# MAINTENANCE BULLETIN

NO. 162  
JUNE 1999

## ALFA COMPANY

Typical Accumulator  
(1) 149 3251 Retaining Ring Service Kit

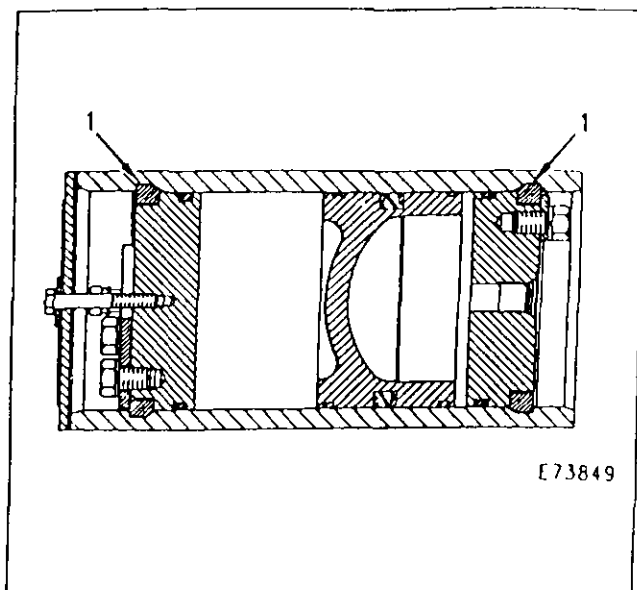
9J 4018 and 9J 4019 Retaining Rings (no longer serviced) are replaced with 149-3251 Retaining Ring Service Kit (1) for caps in accumulators for cushion blade attachment or brake systems for the following machines.

Location of 4E-4521 or 129-4143 Brake Pressure Switch for 988F (8YG) and 988F Series II (2ZR) Wheel Loaders.

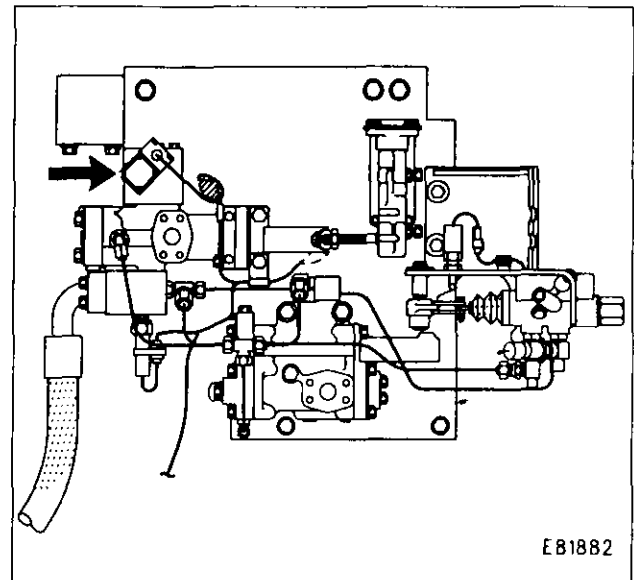
The transmission neutralizer is factory set to activate when the brake pressure reaches 792 kpa (115 psi). However, this can be too high in some applications. Ideally, the neutralizer should activate at the lowest brake pressure required for a customer's application. Neutralizing early with less pressure on the brakes increases axle, brake, and tire life. This also reduces the force required by the operator to depress the pedal, thus reducing leg fatigue.

8. Remove 129-4143 or 4E-4456 Transmission Neutralizer Pressure Switch.
9. Install one 5H-4019 Cover.

10. Attach a 6890 kpa (1000 psi) gauge to monitor wheel brake pressure.
11. Toggle the neutralizer lockout switch to the OFF position. When this switch is ON, the transmission will not neutralize when the 9X-4232 Switch closes.
12. Start the machine and allow enough time for the brake system to recharge.
13. Engage the transmission in first speed forward, and while the machine is moving, slowly depress the left brake pedal.
14. Monitor the brake pressure as the transmission neutralizes.

**Note:** For truck loading applications, experience has shown that 551 kpa (80 psi) is desirable.

Illustration 1: Typical Sensor-Dial location (1).

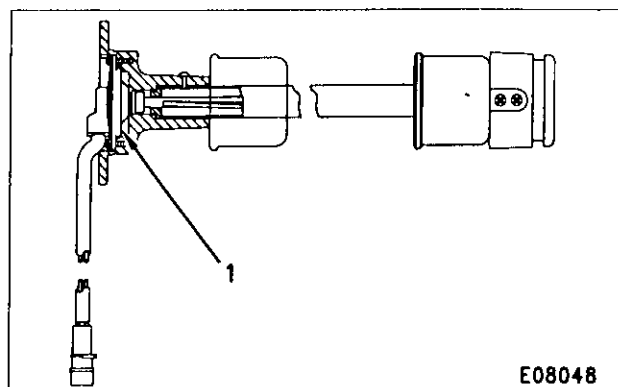
**Description Of Change:** The sensor-dials resistive elements in the fuel level senders have been improved internally to prevent intermittent or open conditions.

**Adaptable To:** The 138-0444, 139-8661, 139-8662, 139-8663, 139-8665, and 139-8666 Sensor-Dials in the Fuel Level Sender Assembly have been improved effective with date code D97 (D = April, 97 = 1997) at the supplier. The improvement can also be noted by checking the part number marked on the top of the complete sender assembly. The change level of the new sender has been marked after the part number. Senders made before the improvement DO NOT have the change level marked after the part number. The part numbers of the improved Sensor-Dials and the part numbers of the former Sensor-Dials are also shown in Chart 1.

The location of the sensor-dial is shown in Illustration 1. To check effectivity for the machine being serviced, and to find the correct Fuel Level Sender Assembly part number and improved Sensor-Dial part number, refer to Chart 2. This is a partial list of effective serial numbers because not all effective serial numbers are known at this time. As a reference, the sensor-dial will read approximately 64 to 255 ohms at the empty position and 0 to 29 ohms at the full position (varies depending on part number-see Chart 3) when using the Caterpillar 6V-7070 Multimeter or equivalent. Typically, the sensor-dial is all that needs to be replaced on a malfunctioning sender assembly.

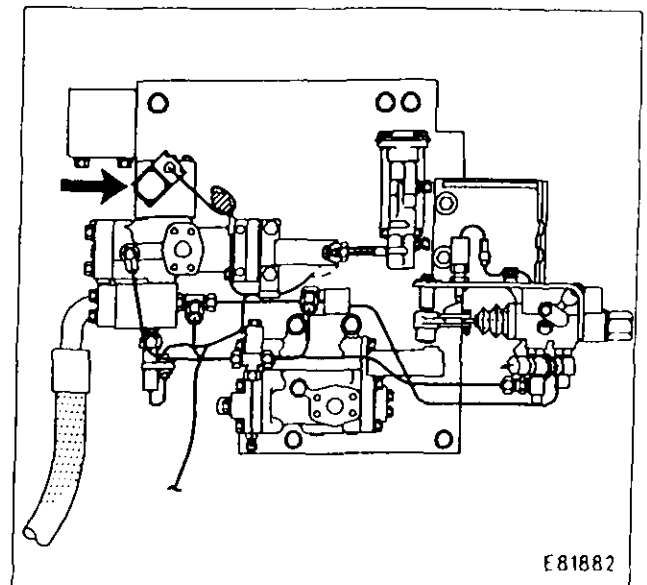
**Description Of Change:** New o-ring seals for the idler gear bolts and idler gear shafts are now being used in the above applications powered by 3408 engines. The seals that are used on the internal idler gear shafts and bolts have been redesigned in order to provide increased engine oil control. The new idler gear shaft that is being used will help to prevent fretting of the rear housing.

**Adaptable To:** The 6V-4365 O-Ring Seals (5) for the bolts on the gear are now being used in place of the former 4J-5309 O-Ring Seals. The 124-1859 O-Ring Seals (4) for the shaft on gear are now being used in place of the former 2H-6338 O-Ring Seals.

The 8L-2777 O-Ring Seals (3) for the bolts on the gear are now being used in place of the former 4J-9535 O-Ring Seals. The 124-1858 O-Ring Seals (2) for the shaft on the gear are now being used in place of the former 7F-8268 O-Ring Seals.

The new 122-9860 Idler Gear Shaft (1) replaces the 106-1541 Idler Gear Shaft in the 4P-3581 Rear Gear Group.

Transfer Case and Gear Group

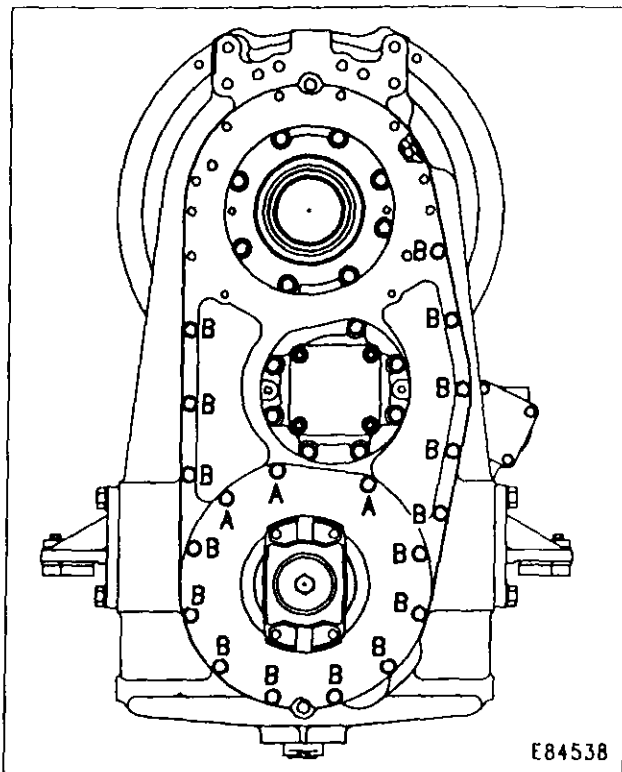
**Description Of Change:** Three bolts that help hold the bearing cage onto the transfer case assembly have been replaced by three longer bolts and three spacers. The torque for the three new bolts (A) and existing bolts (B) has increased from  $105 \pm 20 \text{ N}\cdot\text{m}$  ( $75 \pm 15 \text{ lb ft}$ ) to a torque of  $135 \pm 20 \text{ N}\cdot\text{m}$  ( $100 \pm 15 \text{ lb ft}$ ). The three longer bolts and higher bolt torque will reduce oil leaks between the transfer case and cover assembly.

**Adaptable To:** Three OS-1587 Bolts (A) replace three former 7B-3235 Bolts. Three new 170-7309 Spacers and three 5P-8245 Washers are used with OS-1587 Bolts (A). The new bolts and bolt torque are effective with the transmissions listed in the Table and adaptable to first production for the machines listed.

## Drive Line Bolt Tightening Procedure

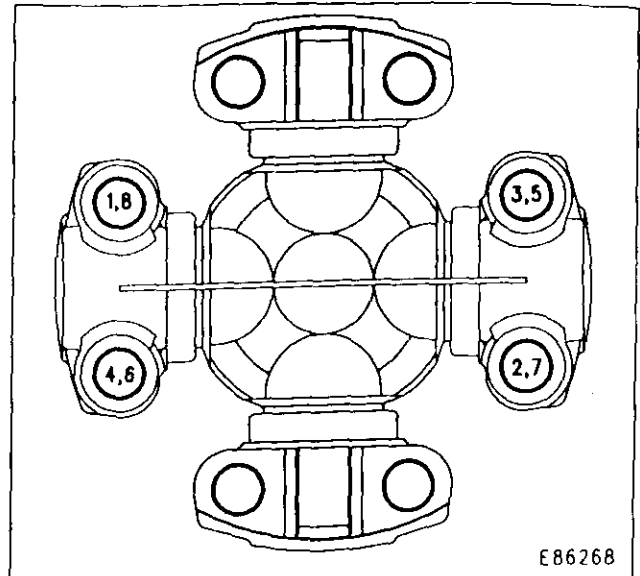
**Description Of Change:** A new tightening procedure is being used for all drive line bolts. This tightening procedure reduces the incidence of loose bolts due to uneven bolt tightening or difficult drive line component fit-up.

**Adaptable To:** This new drive line bolt tightening procedure is adaptable to the machines listed. The following tightening procedure should be used for all drive line bolts.

1. First tighten the bolts using cross pattern sequence (1, 2, 3, 4). Use a torque wrench that is set to the correct torque. This ensures component fit-up and closes any gaps in the assembly.
2. Tighten the bolts again using cross pattern sequence (5, 6, 7, 8). Use a torque wrench that is set to the correct torque. This ensures even bolt tightening.
